Subject: Proof of Publication - Notice of Intent to Issue Air Construction Permit, DRAFT Permit No.: 0570008-013-AC (PSD-FL-234)
; Animal Feed Ingredient Plants at Cargill Fertilizer, Inc.'s facility located at 8813 U.S. Highway 41 South,, Riverview, FL 33569, Hillsborough County.

Re: Cargill Fertilizer, Inc.
Animal Feed Plant - Draft Permit 0570008-013-AC (PSD-FL-234)

Re: Cargill Fertilizer, Inc.
Animal Feed Plant - Revised Draft Permit 0570008-013-AC (PSD-FL-234)

Re: Cargill Fertilizer, Inc., Animal Feed Plant
File No. 0570008-013-AC (PSD-FL-234)

Figure 1
Simplified Flow Diagram of Animal
Feed Plant, Cargill Riverview

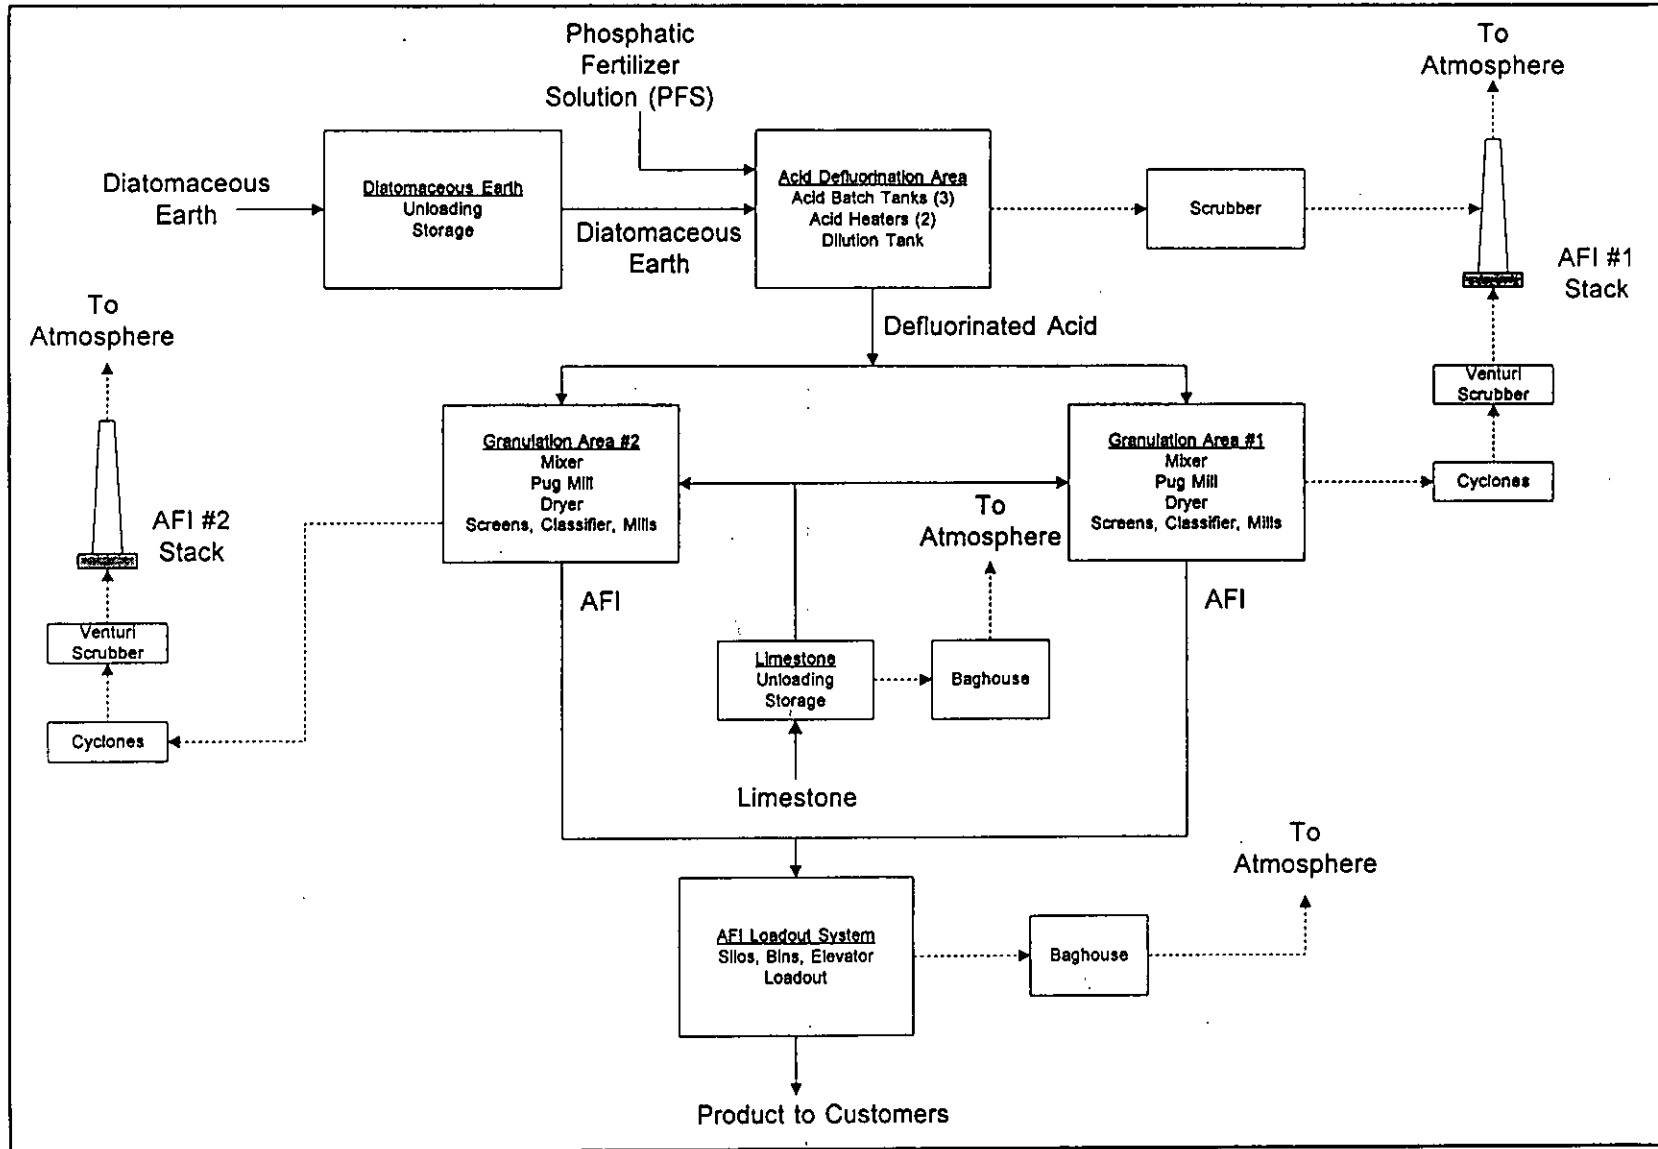
Regarding the facility design, Cargill has determined that the second AFI plant (AFI Plant #2) will only consist of a granulation area. The existing acid defluorination area will be upgraded to support both AFI granulation plants. The design as presented in the original application consisted of two acid defluorination areas, each with two acid batch tanks. Each defluorination area was to process one "batch" of defluorinated acid at any one time in each plant.

The revised design consists of the single existing defluorination area. However, a third acid batch tank and an additional acid heater will be added to complement the existing two acid batch tanks and acid heater. In order to support both AFI granulation plants and to provide more operational flexibility in the defluorination area, two batch tanks may be in use defluorinating acid at any one time.

A flow diagram showing the revised system arrangement is attached as Figure 1. Emissions from the AFI Plant #1 granulation area will exit out the common AFI Plant #1 stack, which also serves the common defluorination area. The AFI Plant #2 granulation area will exit out through a separate stack.

Figure 2-1
Animal Feed Plant Process Flow Diagram

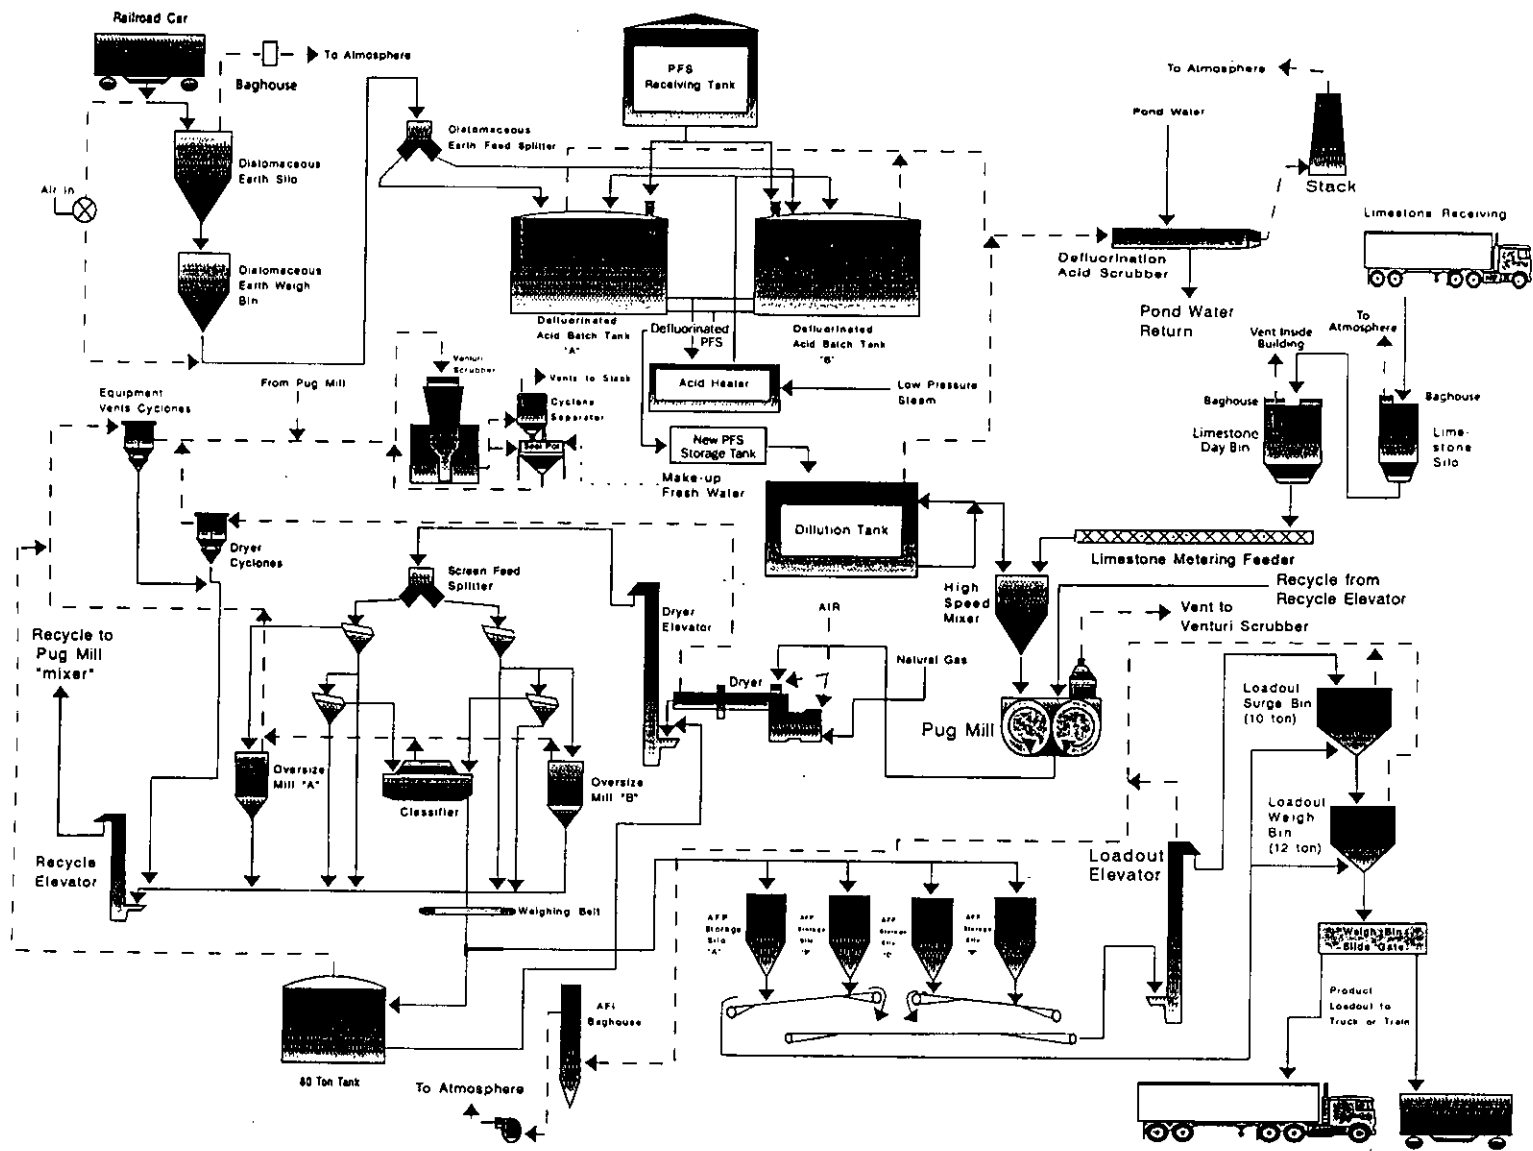
In addition, a new defluorinated acid storage tank will be added to each AFI plant to store defluorinated acid from the two batch tanks within each plant. A revised flow diagram showing the new tank within one of the AFI plants is attached. The granulation area, limestone handling, and product storage, handling and loadout portions of the plant will not be affected by this change.
